**Application ref:** DC/25/1269  
**Location:** Land North of Guildford Road Bucks Green Rudgwick West Sussex  
**Proposal/Description:** Outline Planning Application for up to 90 no. residential dwellings (including 40% affordable) all matters to be reserved apart from access.

Thank you for consulting with Place Services on the above Outline planning application. This letter sets out our consultation response on the landscape impact of the application and how the proposal relates and responds to the landscape setting and context of the site.

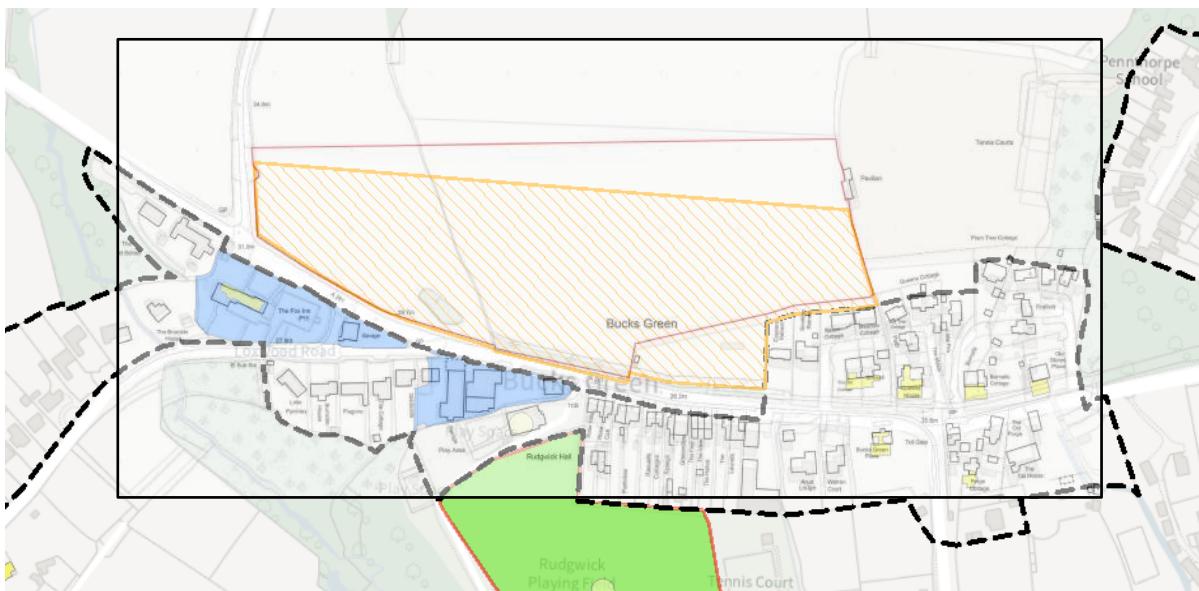
Upon initial review, we note the application extends beyond the draft allocation boundary as shown within the overlay from the Location Plan (Dwg. SLP.05 Rev. A) on the Horsham District Local Plan 2023-2040 Regulation 19 below:

Furthermore, the Land Use Parameters Plan identifies the developable area extends into the northern part of the site, contrary to Policy HA14 which states that *“development will be supported where proposals: a) Are limited to the southern part of the site as shown on the Policies map, with an agreed landscape treatment in the northern part of the site to minimise landscape impacts.”* In addition of the extension into the countryside beyond the RD1 draft allocation, the policy has not been adhered to regarding the developable area.
